42941A-01

S E R V I C E N O T E

42941A Impedance Probe Kit, 40 Hz to 110 MHz

This service note provides the updated part numbers and figures for both RoHS and non-RoHS 42941A Impedance Probe Kit, 40 Hz to 110 MHz

Figure 1-1

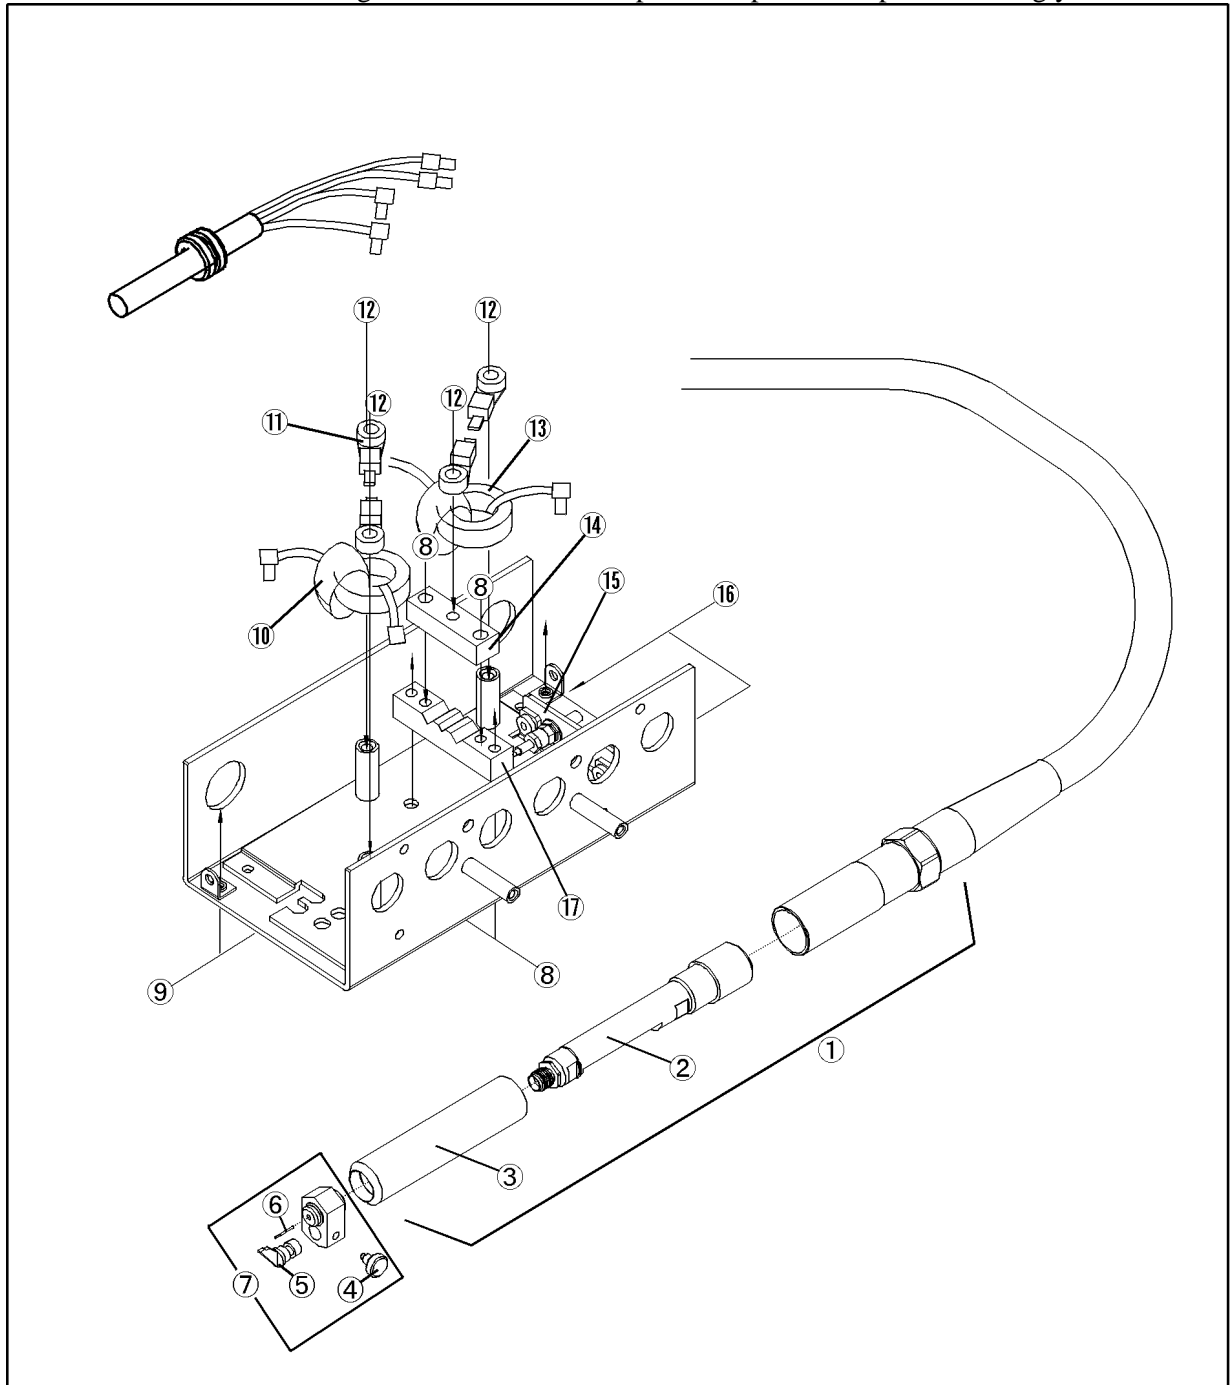
Shown are the supported parts and their respective RoHS compliant replacement support part. RoHS conversion involves with design and dimension change which result in the RoHS support part backward incompatible with non-RoHS 42941A Impedance Probe Kit, 40Hz to 110 MHz. Special handling is needed while using the RoHS replacement part on non-RoHS 42941A. The original support part number is replaced by the respective "RoHS Compliant Replacement Part". Once the original support part is depleted, please proceed to obtain the RoHS compliant support part. Please refer to table 1-1, 1-2 and figure 1-1, 1-2 for the respective replacement part accordingly.

Figure 2-1

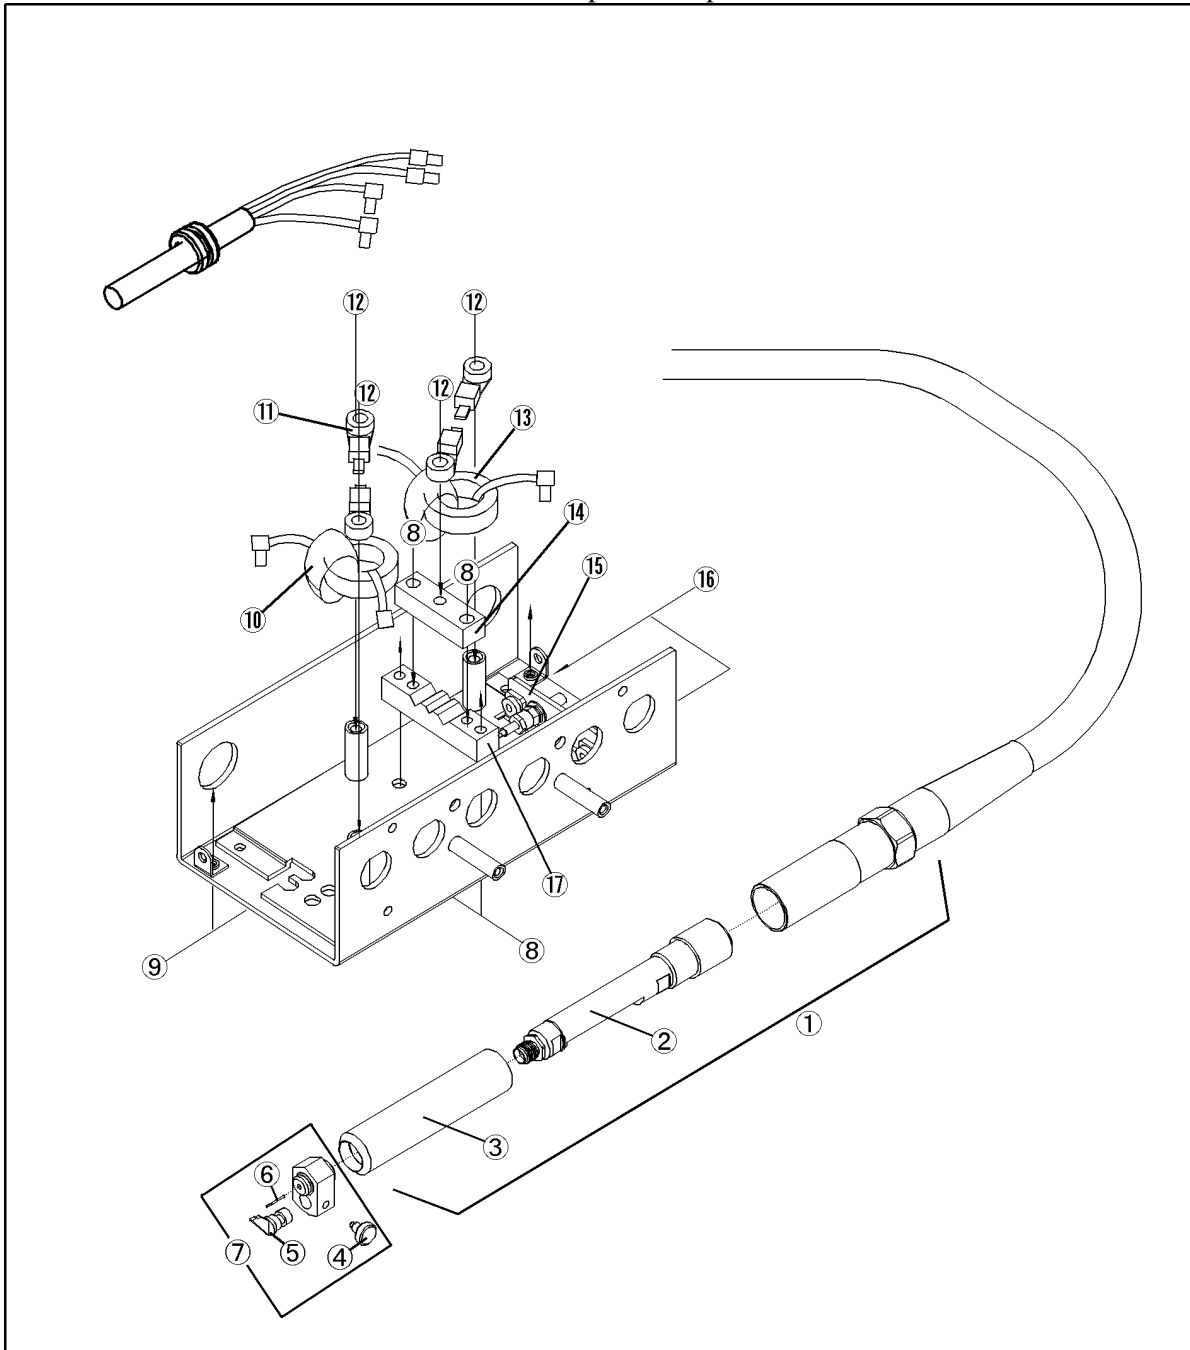
Shown are the support parts for RoHS compliance 42941A Impedance Probe Kit, 40 Hz to 110 MHz. All the listed items are changed at RoHS conversion. Due to limited availability of RoHS compliance station and technical difficulties in RoHS soldering, only parts and support level that do not require RoHS soldering are supported. Shown are the supported RoHS compliance parts for RoHS 42941A Impedance Probe Kit, 40 Hz to 110 MHz.

Shown in table 2-1, 2-2 and figure 2-1, 2-2 are the respective support parts for RoHS compliance 42941A unit. Parts shown in table 2-1, 2-2 are replaceable parts for RoHS unit.
